HILLCREST COMMONS

SUPPLEMENTAL

FINAL ENVIRONMENTAL IMPACT STATEMENT

NYS Route 52
Towns of Carmel and Kent, New York

Figure 1-2: Revised Site Plan-
 Hillcrest Commons
 Towns of Carmel and Kent
 Putnam County, New York
 Source: Insite Engineering, Surveying & Landscape Architecture, P.C.
 Date: 3/11/09

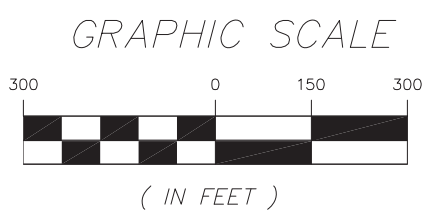
Comment 3-12 (August 26, 2009, Hillcrest Commons Public Hearing, Ms. Lori Kemp): There are no blasting laws in New York State, so you're kind of on your own. I was wondering, is it going to be this whole row (indiscernible) are you removing all those trees?

Response 3-12: Trees and vegetation will only be removed within the limits of disturbance, as shown in Figure 1-2 Revised Site Plan. As shown in the figure, trees will be preserved over a large portion of the property, including at the top of the hill near the water tank and along the eastern property line, bordering the Hill and Dale neighborhood.

Figure 4-1: Revised Wetland Boundary
 Hillcrest Commons
 Towns of Kent and Carmel, Putnam County, New York
 Source: Insite Engineering, 10/21/09
 Scale: 1" = 50'

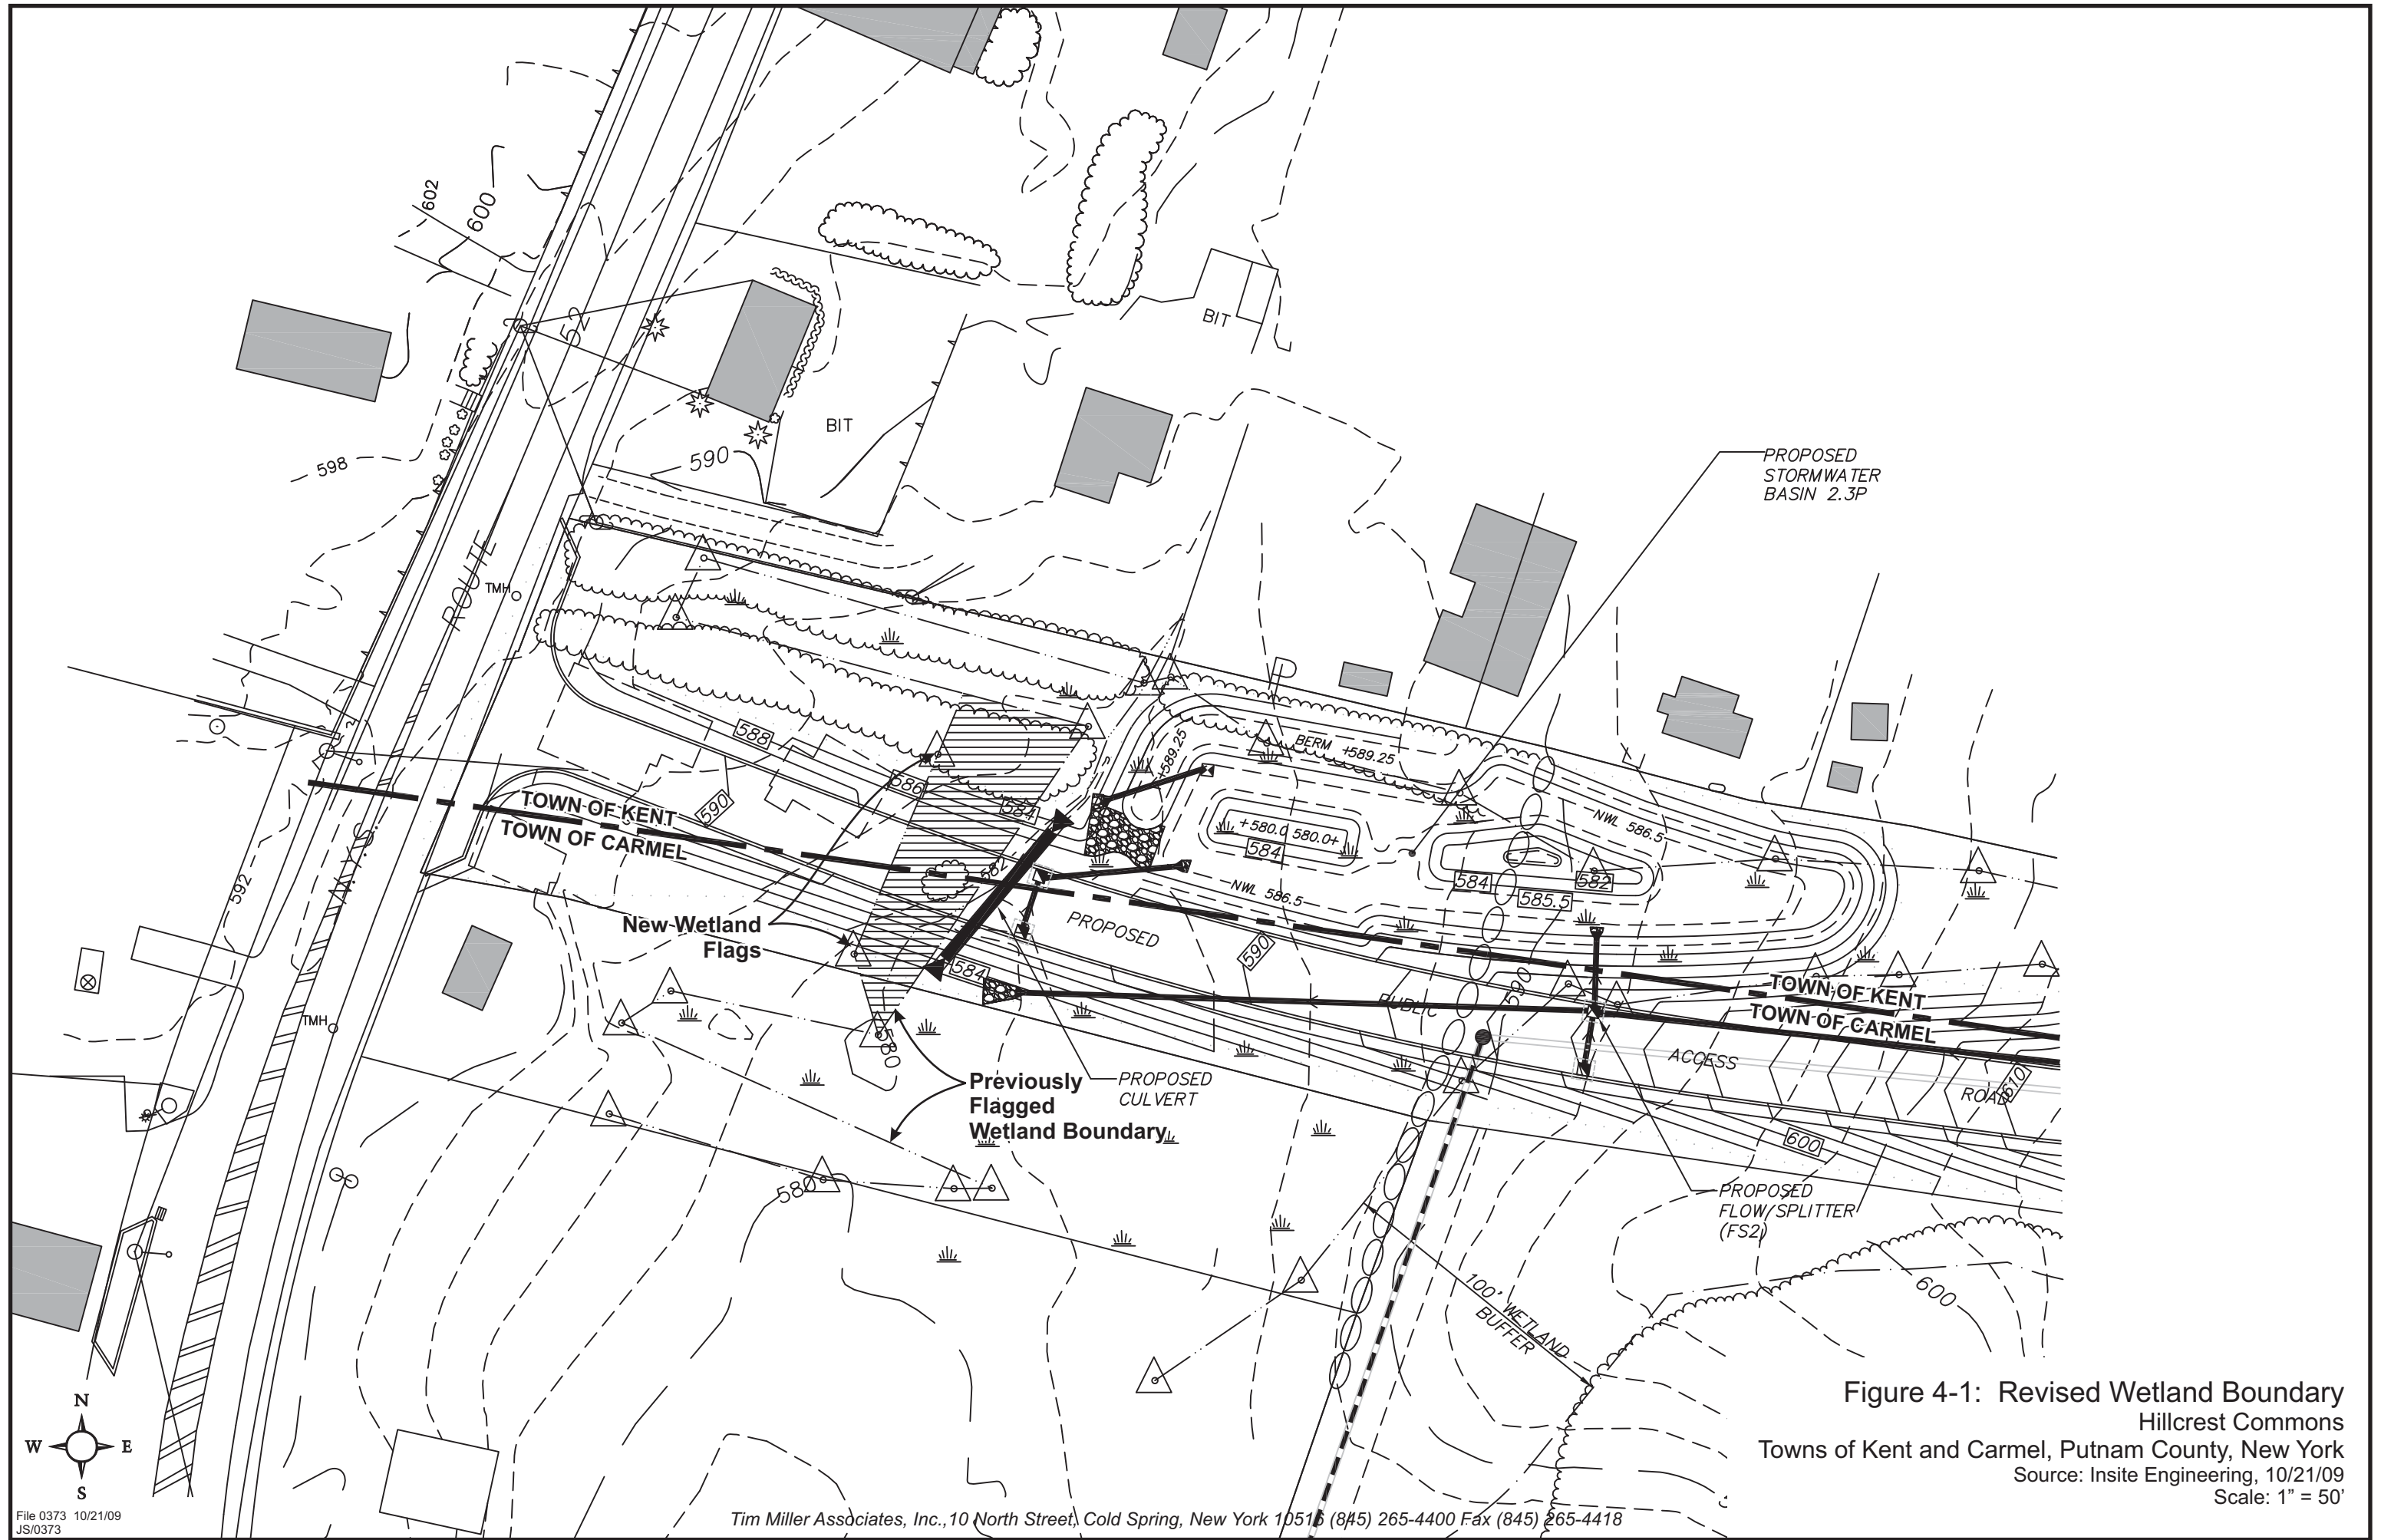
Comment 4-2 (Letter #5, September 21, 2009, Cornerstone Associates, Bruce Barber, Town of Kent Environmental Consultant): Site inspection utilizing methodology found in Chapter 39A of the Town of Kent Town Code revealed an additional wetland area adjacent to Flag #17 as depicted on Figure 3.2-4 in the SDEIS. It is requested that a NYS Licensed Land Surveyor update the completed wetland field boundary determination and provide calculation of the total area (in square feet) within the wetland boundaries in the Town of Kent to determine if the wetland area meets jurisdictional size requirements. If found to be a jurisdictional Town of Kent wetlands, additional review and comment will be required.

Response 4-2: Comment noted. The area in question has been flagged in the field and located by a licensed surveyor. This additional wetland area (0.05 acres in the Town of Kent, 0.08 acres total) is shown in Figure 4-1. Project plans will be updated to reflect this recently revised wetland line. It is anticipated that there will be additional review and comment of this proposal during the site plan and wetland application review before the Town of Kent. It has not been determined at this time whether the area in question is regulated as a wetland by the Town of Kent, or is part of a watercourse and watercourse setback under the Kent Code.
